Well Name: EAGLE 34 C FED	Well Location: T17S / R27E / SEC 34 / NENW /	County or Parish/State: EDDY / NM
Well Number: 5	Type of Well: OIL WELL	Allottee or Tribe Name:
Lease Number: NMLC064050A	Unit or CA Name:	Unit or CA Number:
US Well Number: 300152909600S1	Well Status: Producing Oil Well	Operator: REDWOOD OPERATING LLC

**Notice of Intent**

Type of Action: Plug and Abandonment

<b>OPERATOR NAME:</b>	Redwood Operating, LLC
<b>LEASE NO.:</b>	NMLC064050A
<b>WELL NAME &amp; NO.:</b>	Eagle 34 C Federal #5
<b>US WELL NUMBER:</b>	30-015-29096
<b>LOCATION:</b>	Sec 34, T17S, R27E
<b>COUNTY:</b>	Eddy County, NM

Redwood Operating, LLC		PROPOSED	
Author:	Abby @ BCM	Well No.	#5
Well Name	Eagle 34C Federal	API #:	30-015-29096
Field/Pool	Red Lake (Q-GB-SA)	Location:	Sec 34, T17S, R27E
County	Eddy		330' FNL & 1650' FWL
State	New Mexico	GL:	3528
Spud Date	3/24/1997

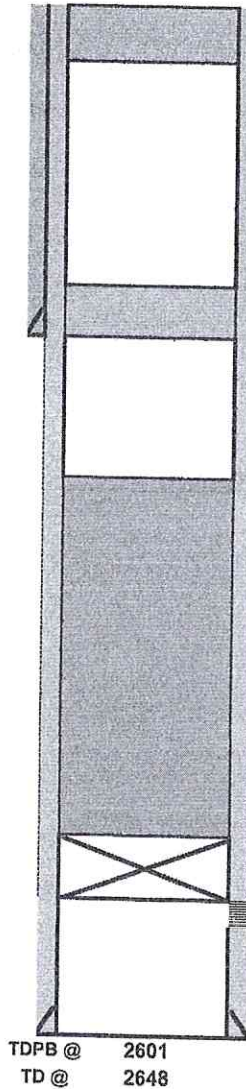
3. Spot 25 sx cmt @ 200' to surface.

2. Spot 30 sx cmt @ 1104'-845'. WOC & Tag (8 5/8" Shoe & Queen)

1. Set 5 1/2" CIBP @ 1862'. Circ hole w/ MLF. Pressure test csg. Spot 70 sx cmt @ 1862-1200'.  
(SA, Premier, GRBG)  
Perfs @ 1912-2394

APPROVAL SUBJECT TO  
GENERAL REQUIREMENTS AND  
SPECIAL STIPULATIONS  
ATTACHED
